**Re: Newfoundland and Labrador Hydro ("NLH") 2018 Capital Budget Application
Revised Information pursuant to Board Order P.U. 43 (2017)**

IOC hereby files its written comments with regards to the MFA-HVY line.

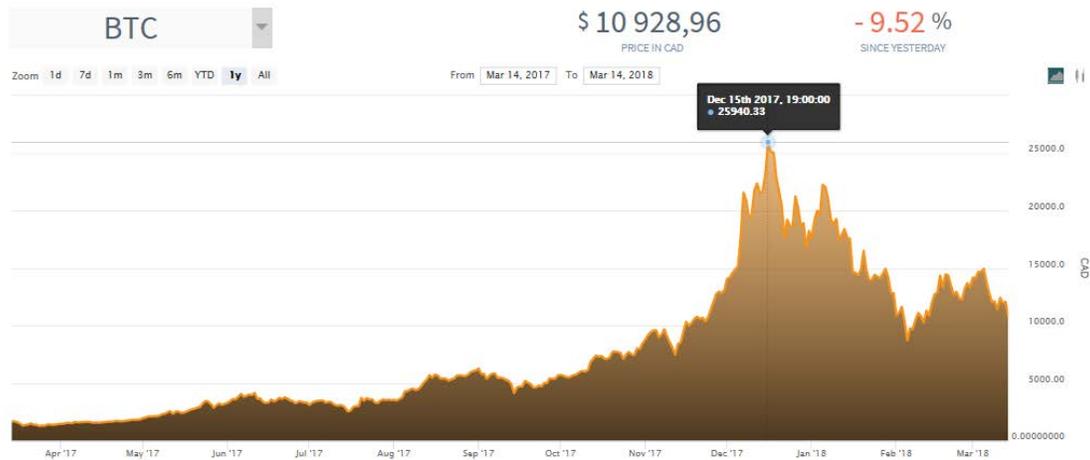
This new demand from cryptocurrency miners is volatile³ and may not last as their market is in constant evolution as computers must be regularly replaced with more performing models and as their income varies with the value of the cryptocurrencies. As illustrated below, the value of the Bitcoin, the most famous of them, varied from 3,542.95 \$ on July 28, 2017 when NLH’s application was filed, to 25,940.33 \$ when it reached its peak on December 15, 2017 back to 12,474.37 on March 12 and finally 10,928.96 \$ today, a mere two days later.

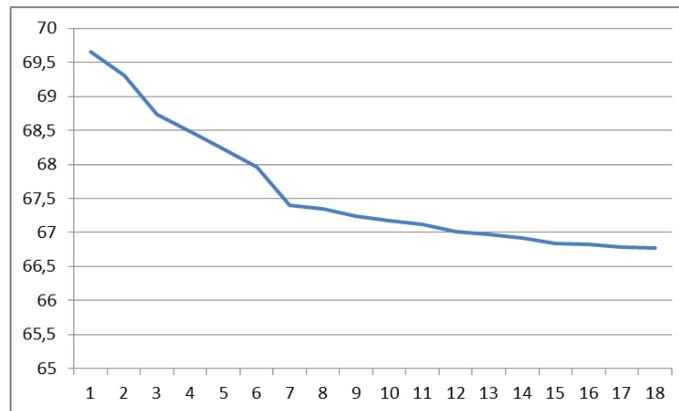
NLH takes the position that it must serve the very fine peak load of the system in all circumstances. This position does not give adequate weight to alternatives, including to the marginal cost of serving the last MW. While it is an adequate goal to improve service continuity to Happy Valley, it cannot be inferred that the current investment addresses it.

According to NLH's response LAB-NLH-008, this short duration peak serviced by L1302 on the Labrador East system lasts less than 10 hours per year. Looking at peak demand for the

last two years – most representative of the current customer base⁶ – we observe a sharp decline of about 3 MW in the first hours of the load duration curve⁷.

We understand from the record that the investment is to be triggered by the addition of a 7.6 MW coincident peak⁸ mostly from cryptocurrency miners to a system that can support a maximum load of 77 MW⁹. Then, if the peaks that may provoke a voltage collapse last a few hours per year, is a long term solution necessary¹⁰?
